## ADDENDUM 4

September 11, 2018

### Contract 15-C-00044; Louisiana Pump Station Rehabilitation

LOUISIANA PUMPING STATION  
REHABILITATION  
DOOR, WINDOW AND LOUVER SCHEDULES

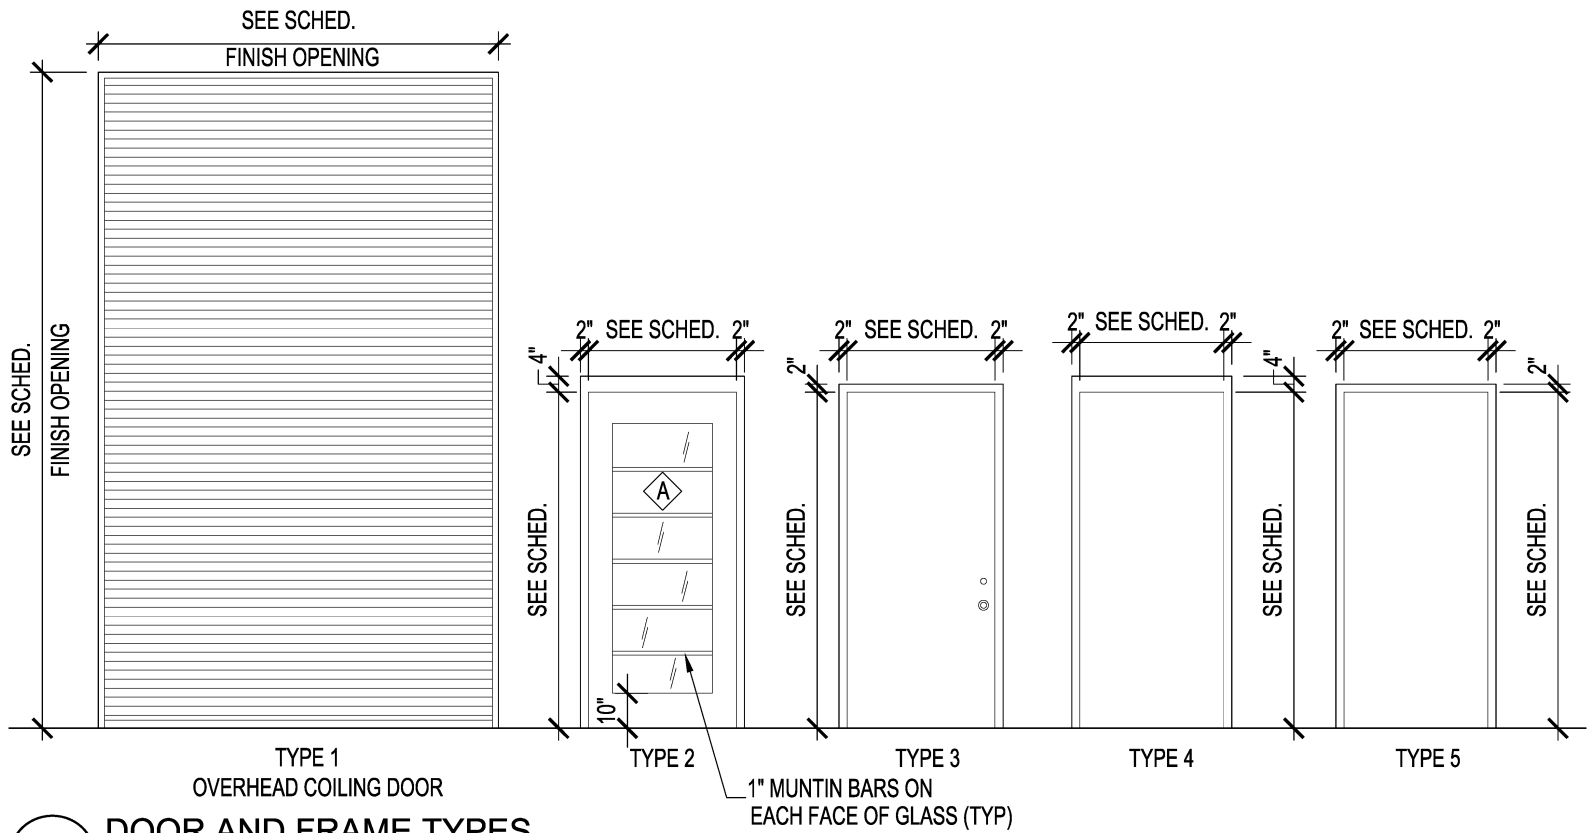
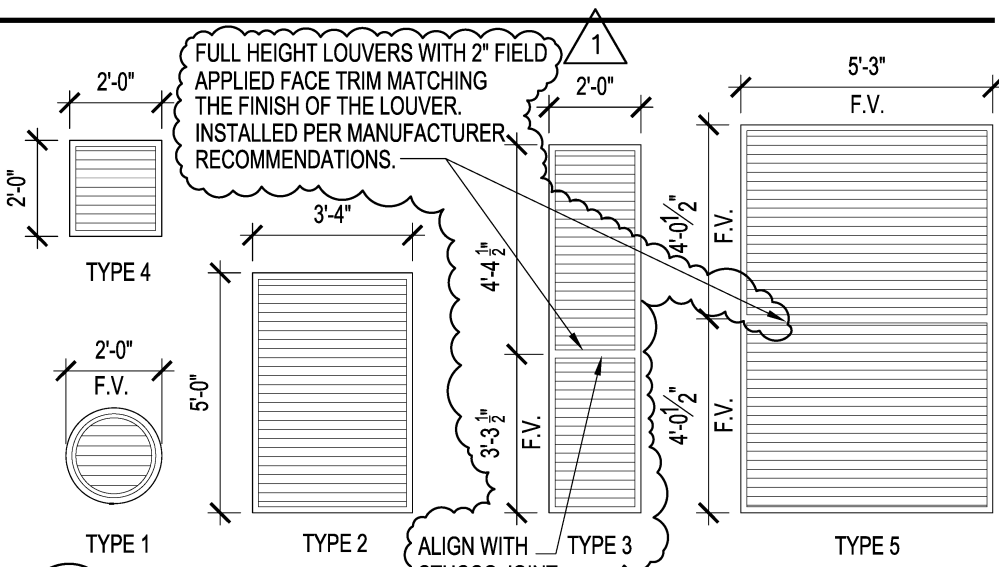
Item 4: Replace Architectural Sheets A-17 and A-18 with the attached revised sheets.
